Extinction ratio in DR links (comment 199)

Piers Dawe

NVIDIA

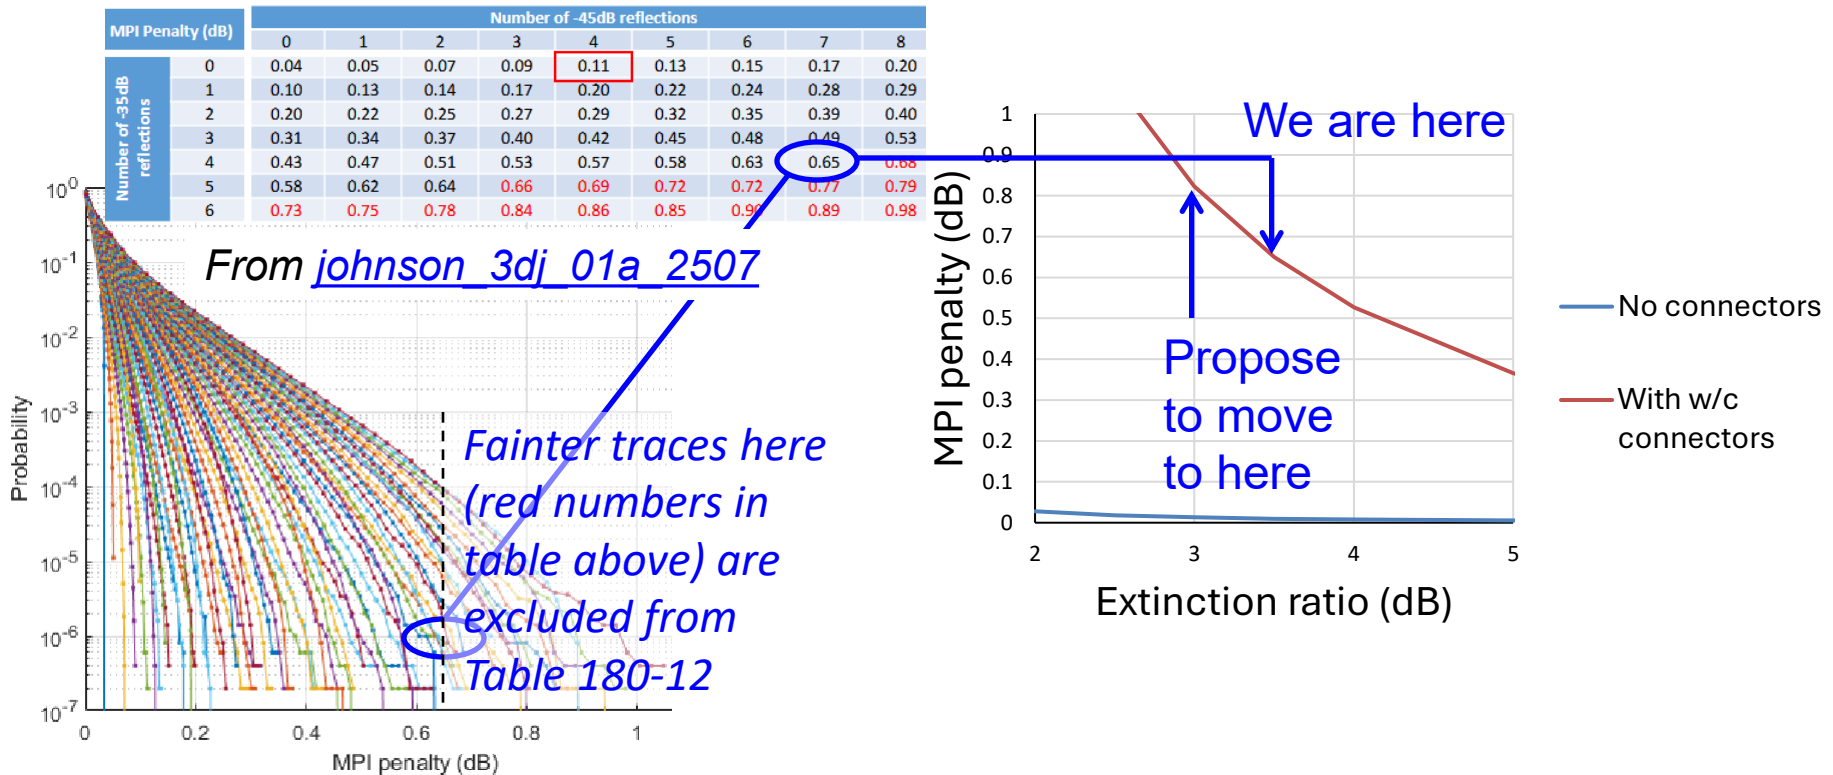
- The 0.1 dB mentioned (actually 0.11 dB per [johnson 3dj 01a 2507](#)) applies to a cell where 3 dB loss is allowed
 - This is barely changed at 3 dB extinction ratio: it rounds to 0.1 dB
- The worst allowed cell at the bottom of the table represents an MPI penalty of 0.65 dB. "We are here" on next slide

Average power vs. OMA map

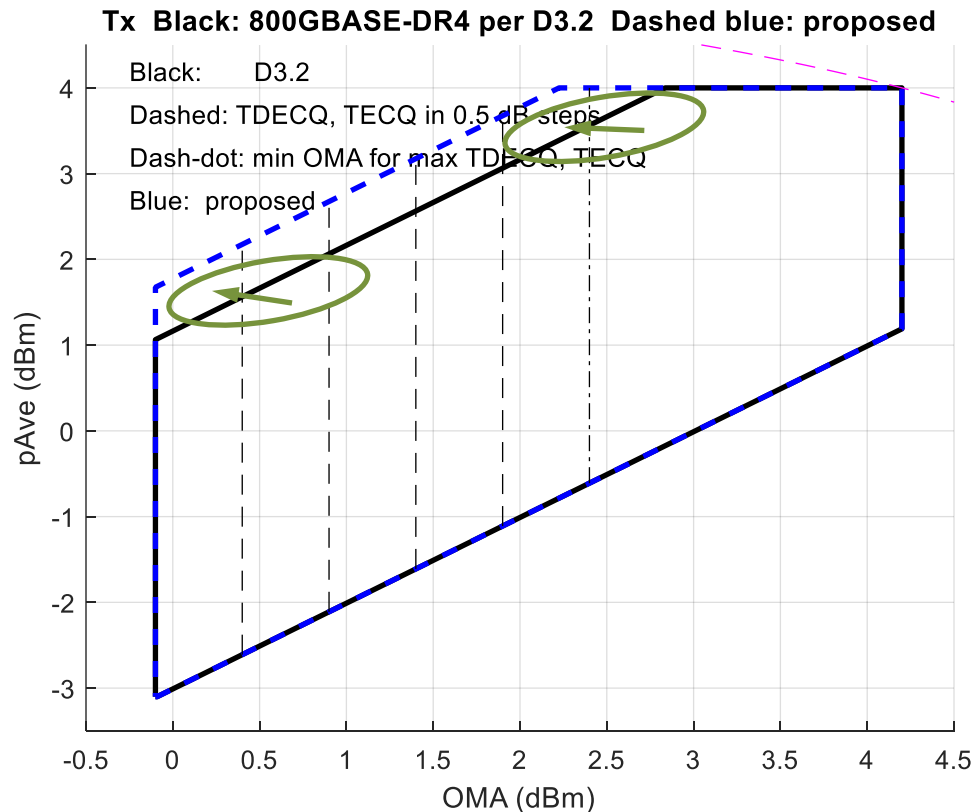
- Changing the min extinction ratio from 3.5 dB (black) to 3 dB (blue). Dashed and dash-dotted ECQ lines don't change
- Example areas of interest in green
- Thin magenta line is locus of constant power in 3s, showing that receiver is not exposed to more power in 3s by the change

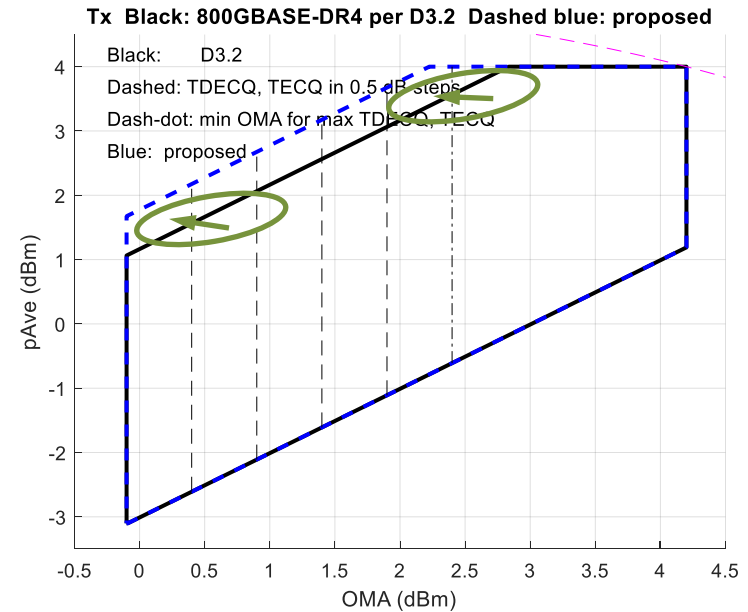
- Revise Figure 180–4, Receiver sensitivity ($\text{OMA}_{\text{outer}}$), each lane (max)
 - and
- Figure 180–5, Transmitter $\text{OMA}_{\text{outer}}$ each lane versus max(TECQ, TDECQ) and receiver sensitivity ($\text{OMA}_{\text{outer}}$) each lane versus TECQ
- Rx lines move down by 0.2 dB
- Fig 180–3 does not change

Apply all these changes to clause 180 for DR and similar (0.2 dB) changes to Clause 182 for DR-2

Why not like 100GBASE-DR and dawe_3dj_01_2607 option 1?

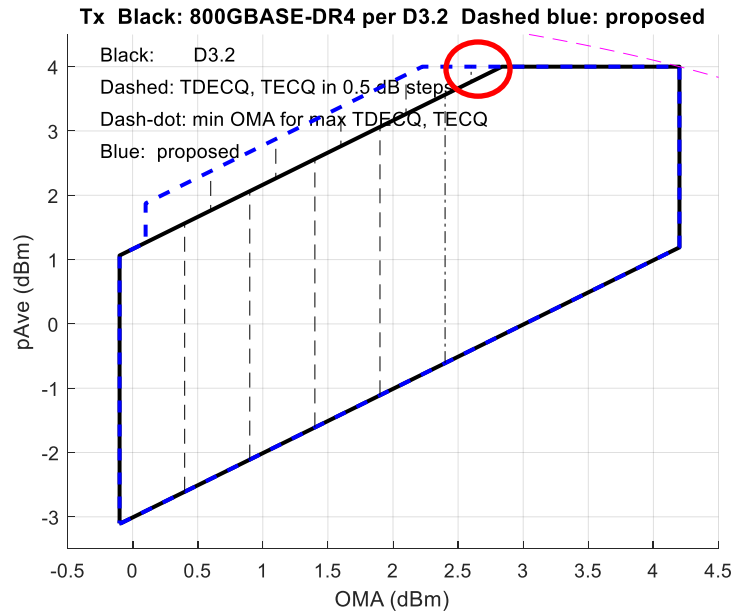
- Left: previous option 1
- (Could be made to work with increased pAve)

Right: previous option 2 = this proposal

This proposal provides better relief for the transmitter with minimal impact on the receiver
